Application Number: 25/0741

Proposal: CONSTRUCTION OF STABLE BLOCK, ALTERATIONS TO ACCESS AND ECOLOGICAL ENHANCEMENTS

Site: Land North Of And Adjacent To St Mary's Church. Church Lane. Marshfield. Cardiff. South Wales

Arboricultural Response.

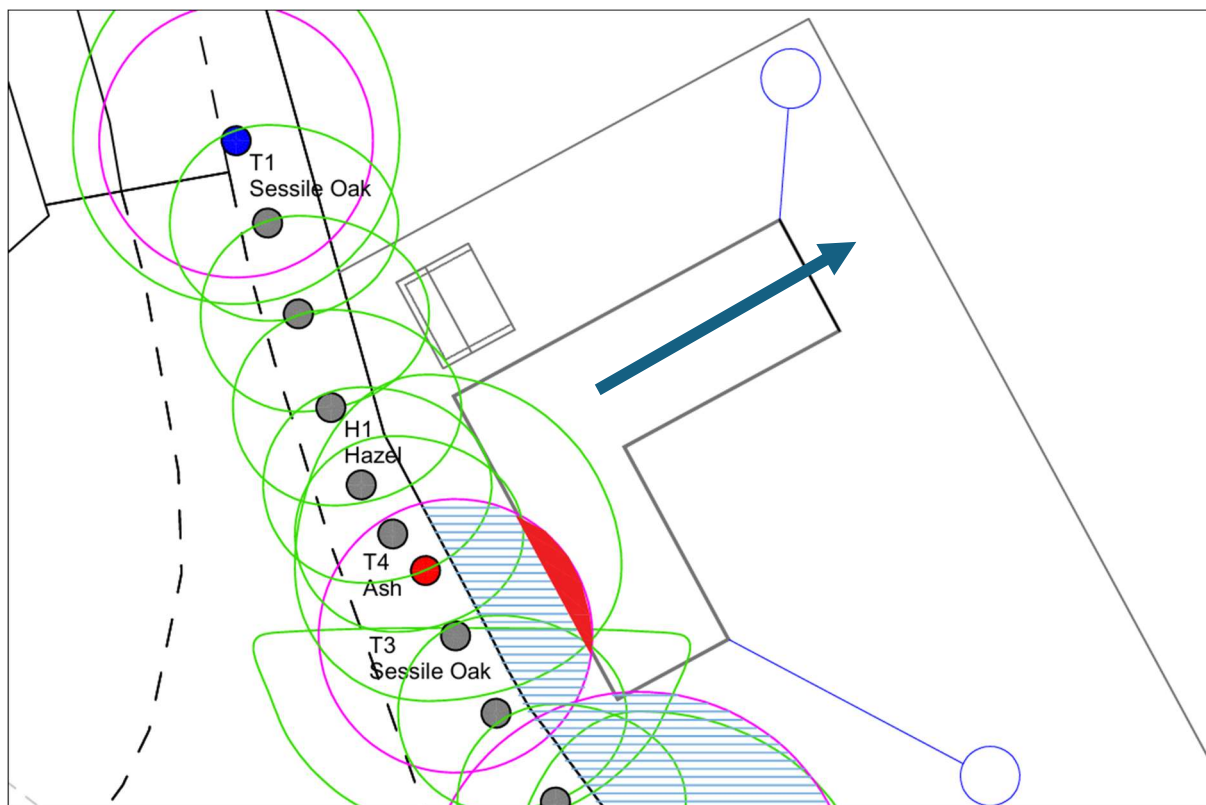
As advised previously - The Tree Protection Plan still shows the infringement by the stable block, into the Root Protection Area of a mature oak T3. Although relatively minor, this mature oak does have restricted rooting potential along the road and therefore the stables should be moved a few metres north-eastwards where there appears to be space, to take it away from the RPA altogether (refer to arrow direction on plan below). All drawings need updating accordingly and should show the Tree Protection Plan as an overlay clearly showing Root Protection Areas, crown spreads and tree numbering.
